AGENDA
HAILEY PLANNING & ZONING COMMISSION
Monday, December 8th, 2014
Hailey City Hall
5:30 p.m.

NB 1 Consideration of a Design Review application by Hailey Ice Inc., represented by Michael Bulls of Ruscitto/Latham/Blanton, for Design Review of a newly constructed indoor ice rink to be located within the Hailey Townsite, Lots 22-24 of Block 126, Lots 10-12 and 20-22 of Block 127, Lots 13-17 of Block 135 and all Lots within Block 134 (771 Main Street South), within the Limited Business (LB) and Townsite Overlay (TO) Zoning Districts.

TO: Hailey Planning and Zoning Commission
FROM: Micah Austin, Community Development Director
RE: Champion Ice House, Hailey Ice Rink Facility
HEARING: December 8, 2014

LOT AREA: 231,360 SQ.FT. (6.31 AC.) **SITE PLAN**

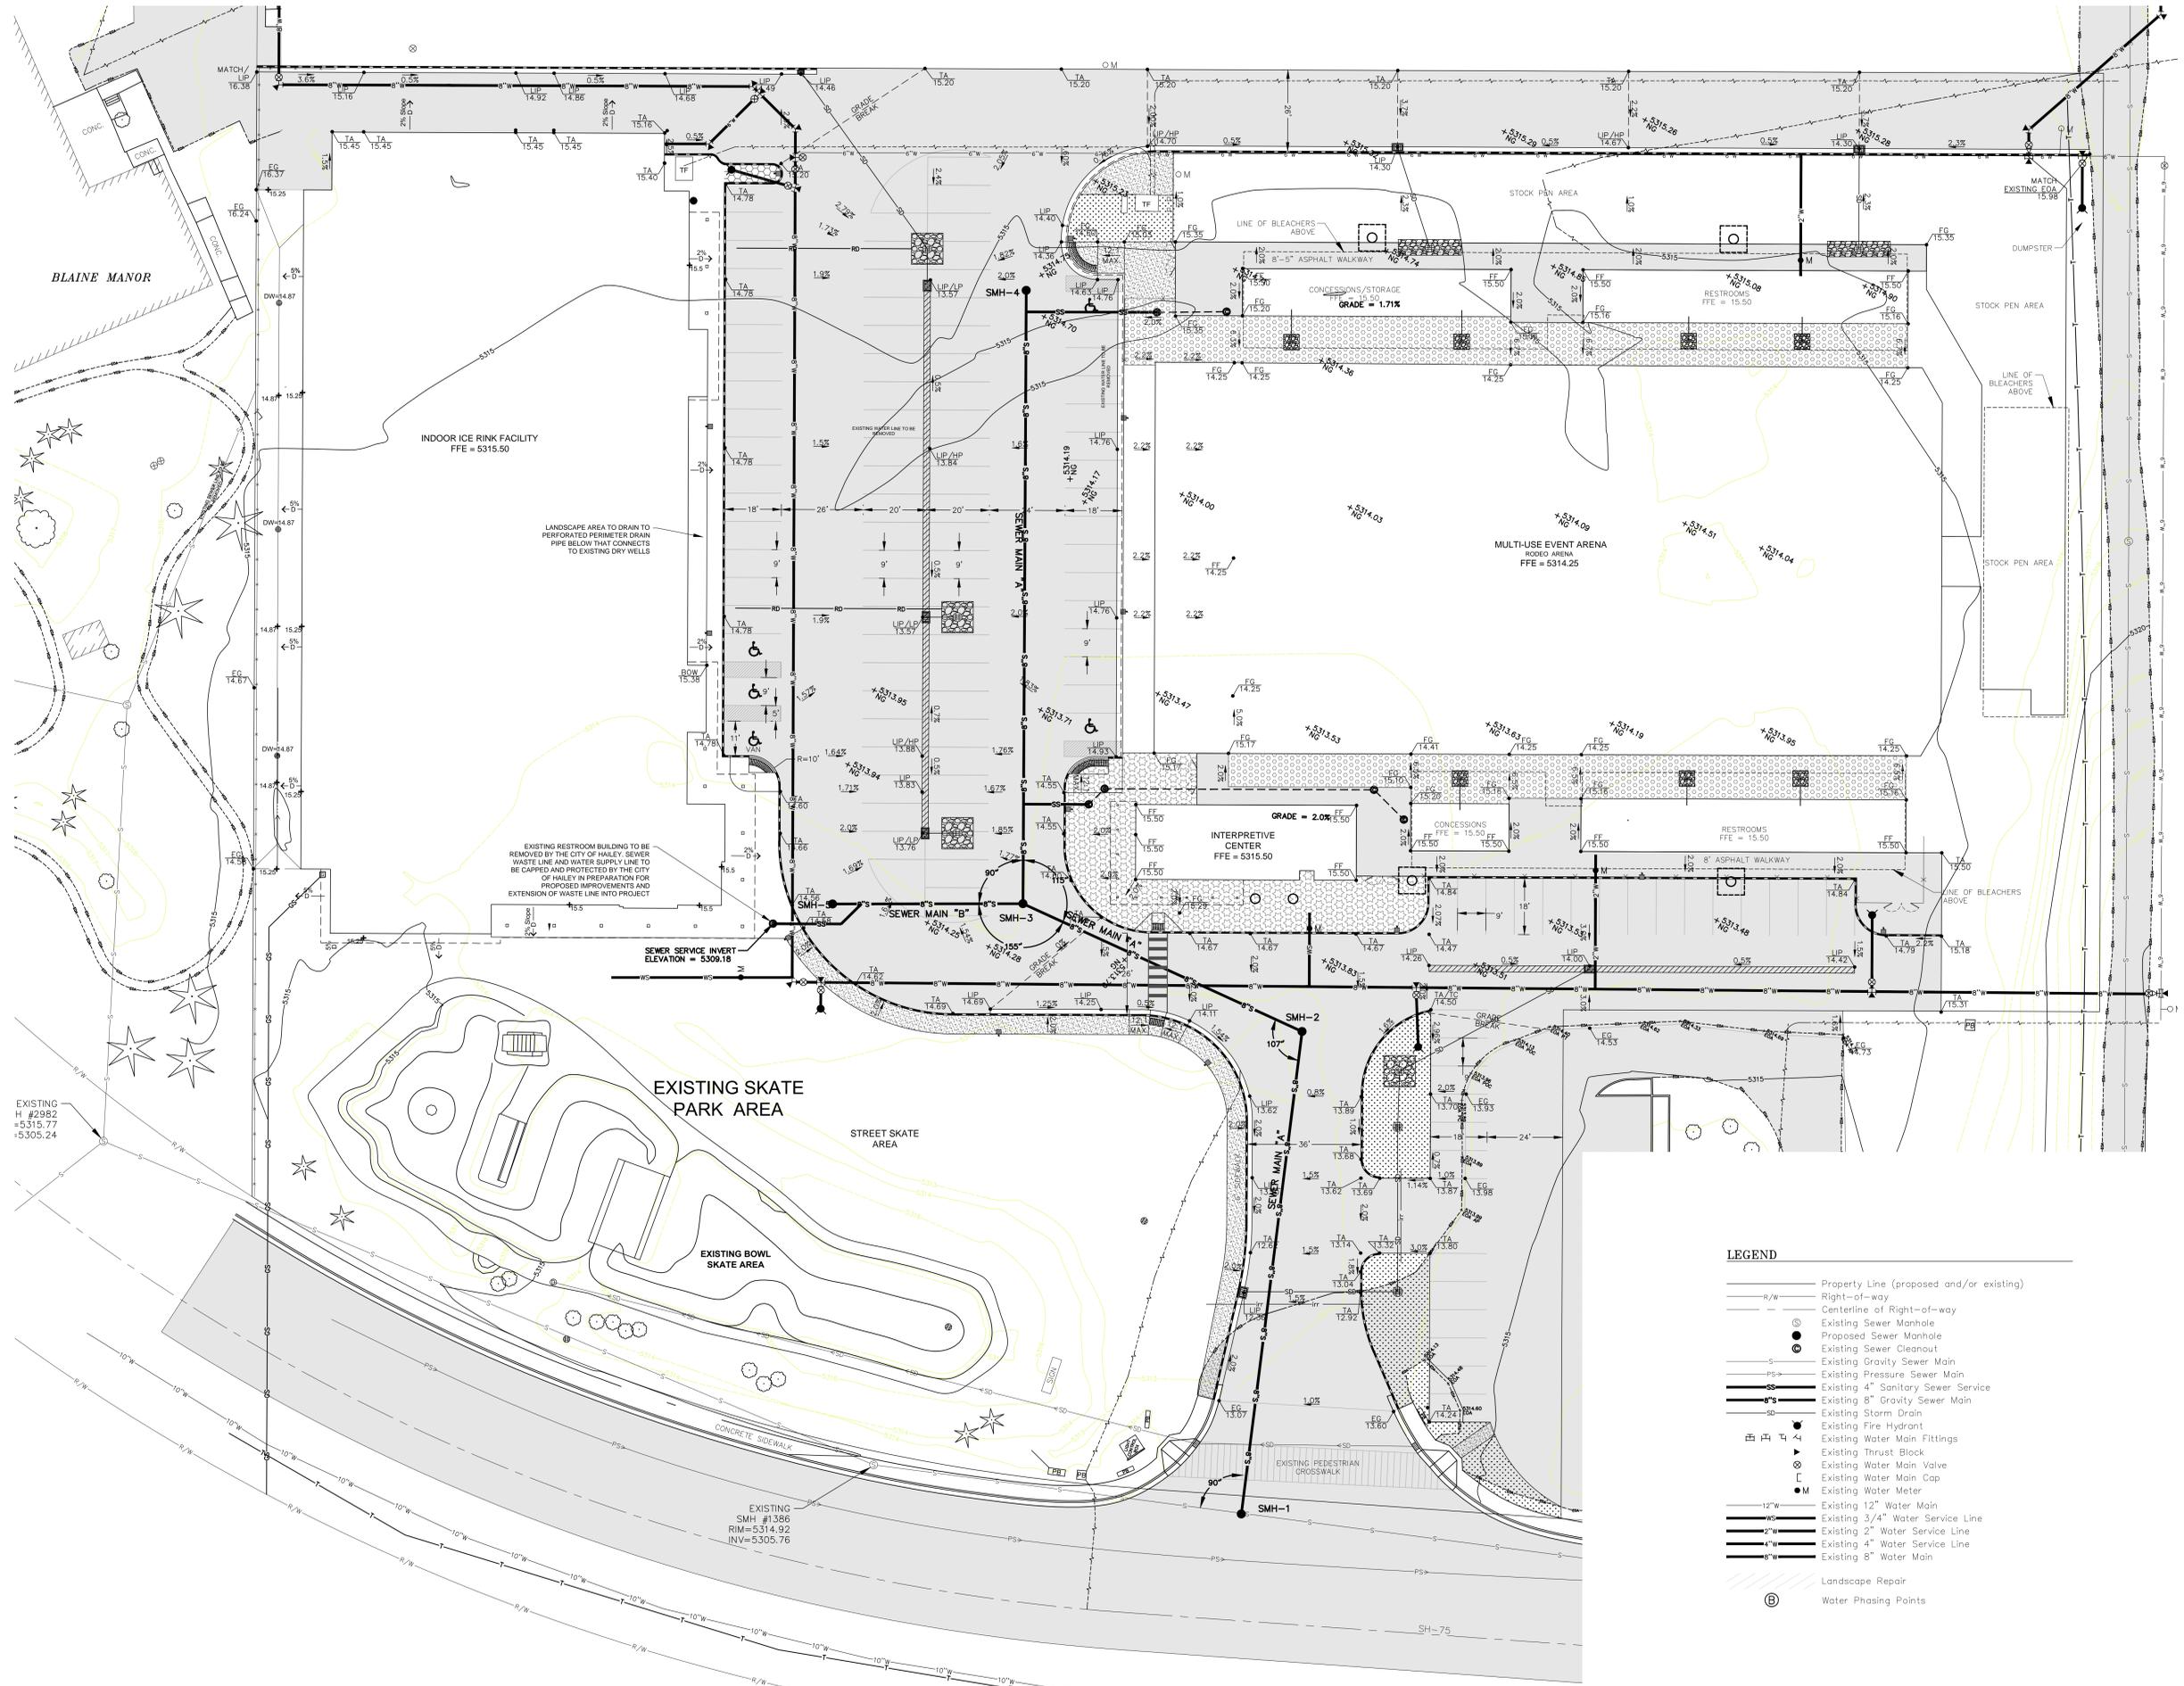
| | | | <i>Staff Comments</i> | <i>- Snow storage areas for the project have been approved in prior applications and are shown on the Site Plan. Refer to Sheet 2.0</i> |

| | | | <i>Staff Comments</i> | Snow storage is shown on the plan as hatched areas and does not impede pedestrian access or circulation. |

| Compliant | | | Standards and Staff Comments | |
|-------------------------------------|--------------------------|--------------------------|------------------------------|--|
| | | | <i>Staff Comments</i> | - The site plan shows a concrete paver sidewalk connecting the existing concrete sidewalk to the entrances and the existing ADA curb cut serving the ADA parking spaces. |

| Yes | No | N/A | City Code | City Standards and Staff Comments |
|-------------------------------------|--------------------------|--------------------------|-----------------------|---|
| | | | <i>Staff Comments</i> | - Site plan shows existing snow storage locations and calculations for required snow storage areas for the entire Werthheimer Park. - Refer to Sheet 2.0 |
| | | | <i>Staff Comments</i> | - Snow storage areas do not restrict pedestrian access. Refer to Sheet 2.0 |

2.1

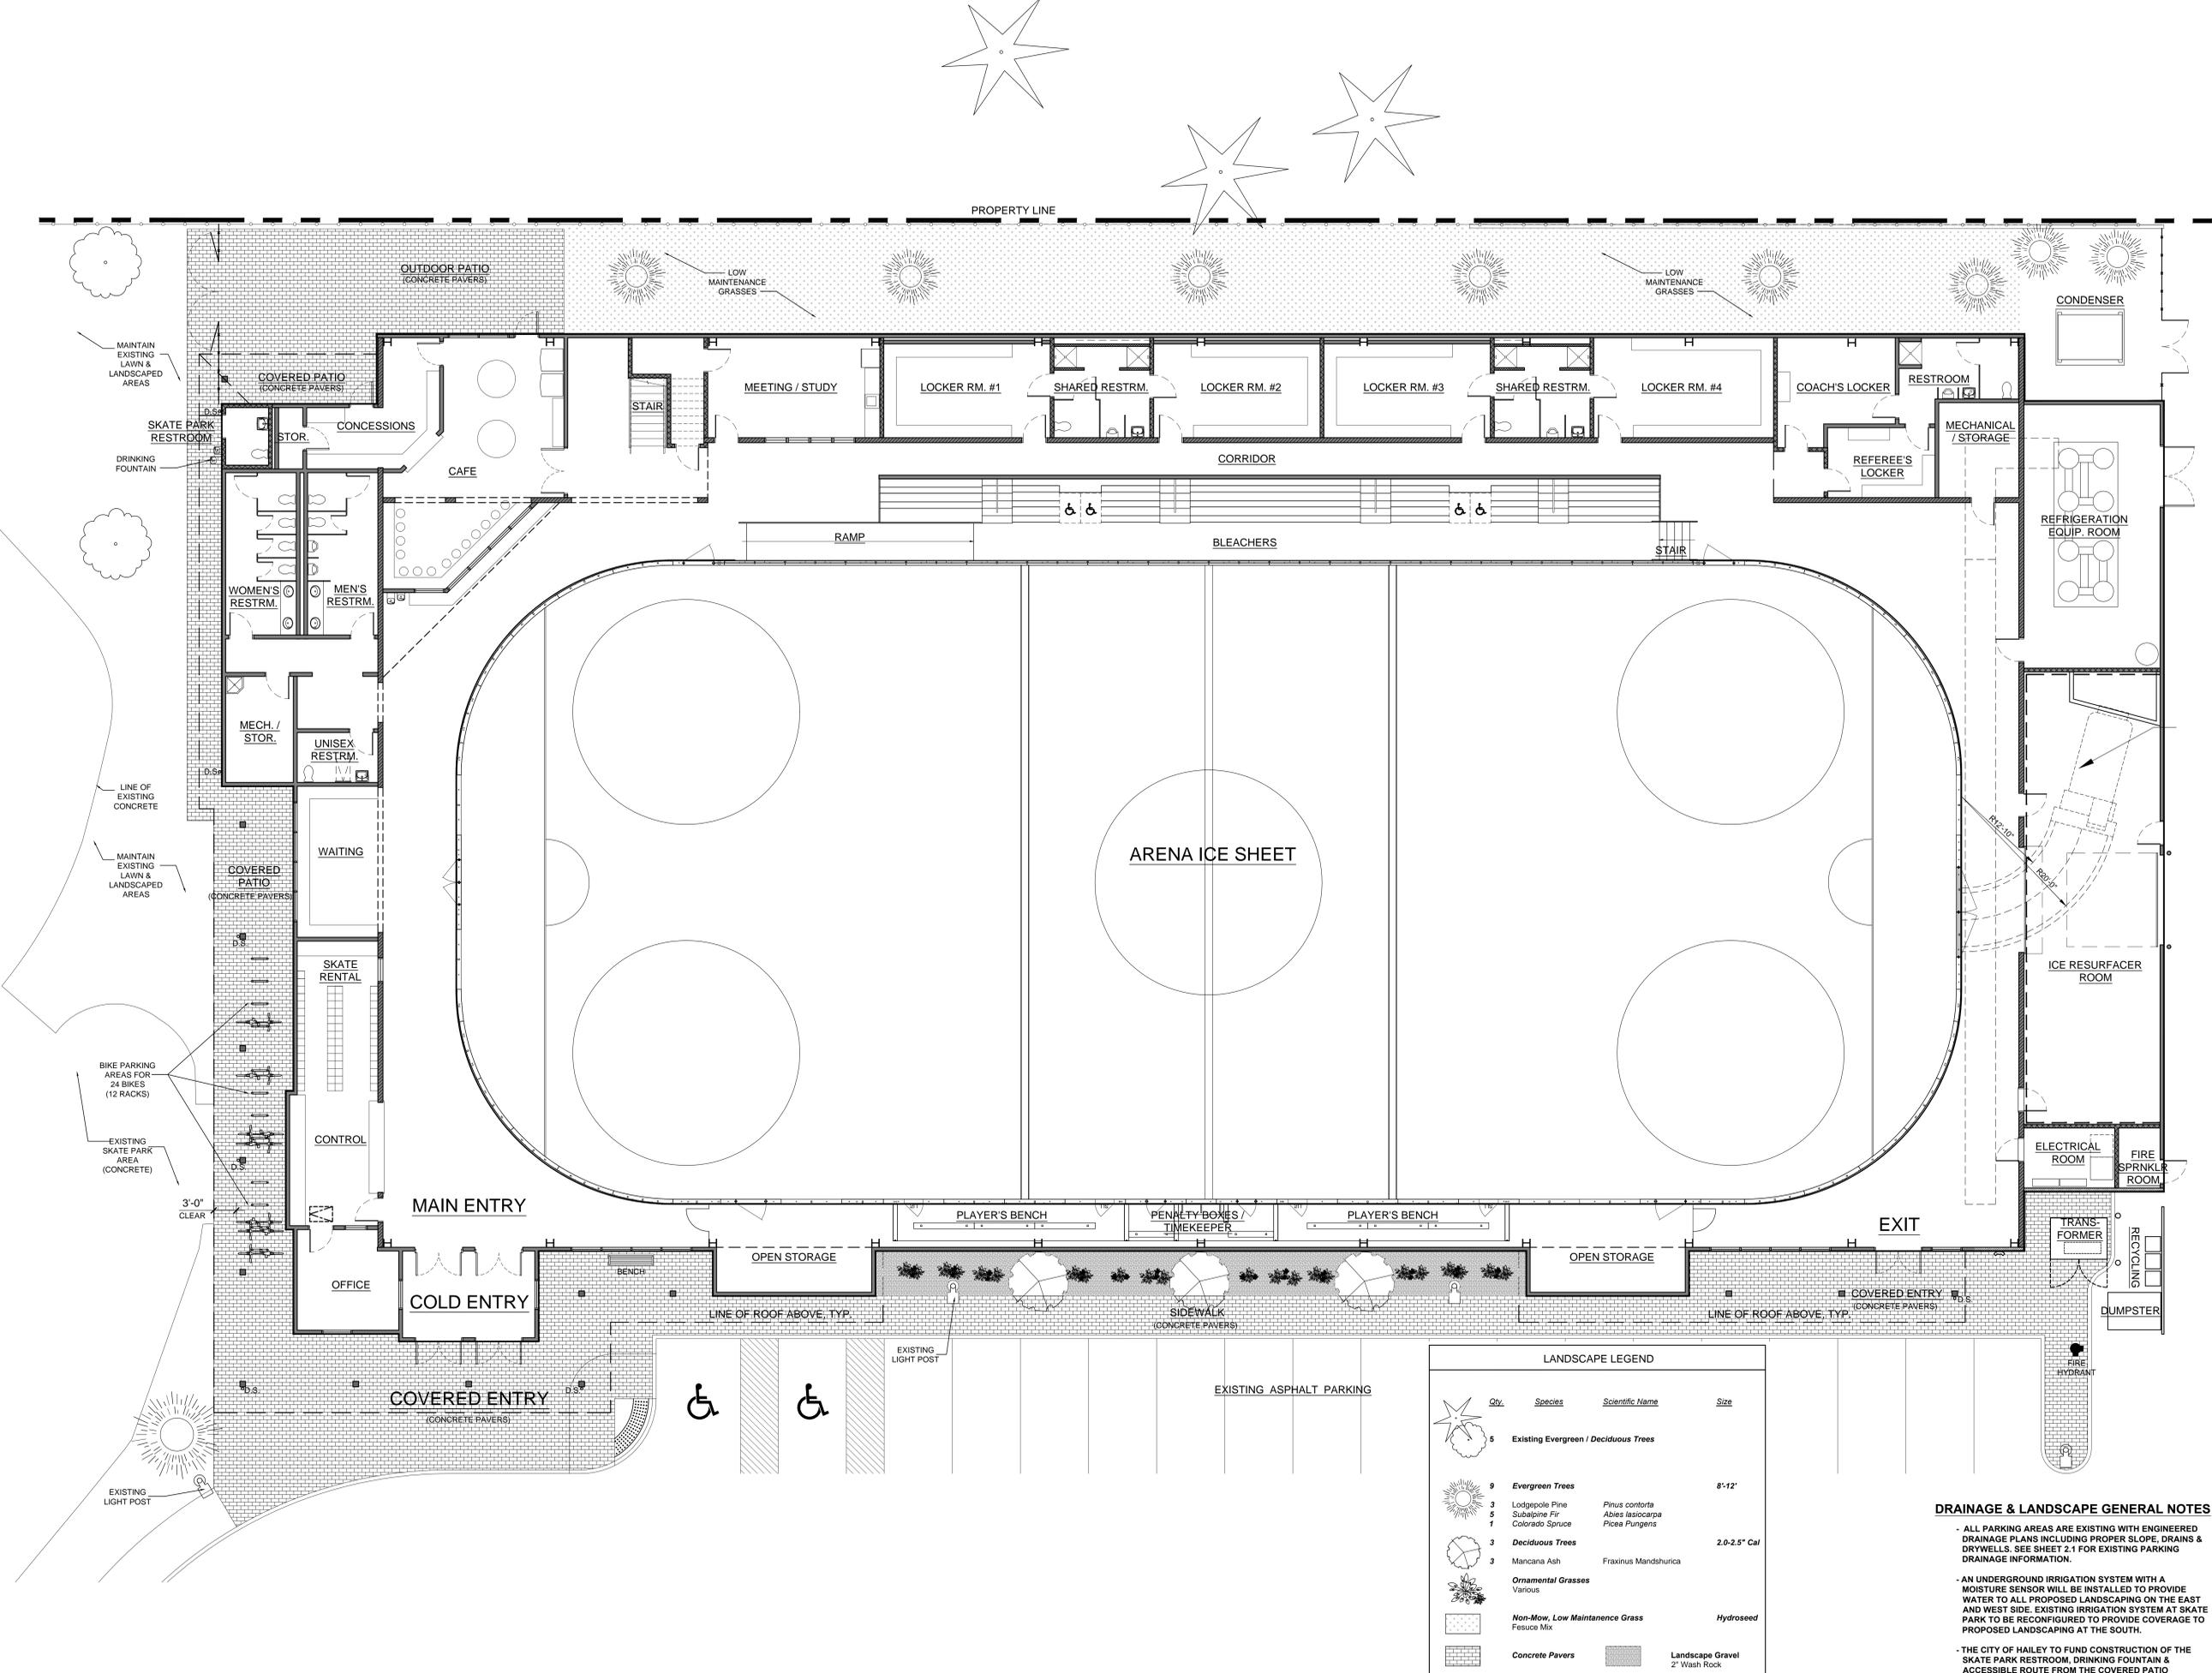
| | | | <i>Staff Comments</i> | <i>- Drainage will be directed to previously installed drainage system. All parking areas are existing with engineered drainage plans including proper slope, drains & drywells. Refer to Sheet 2-1</i> |
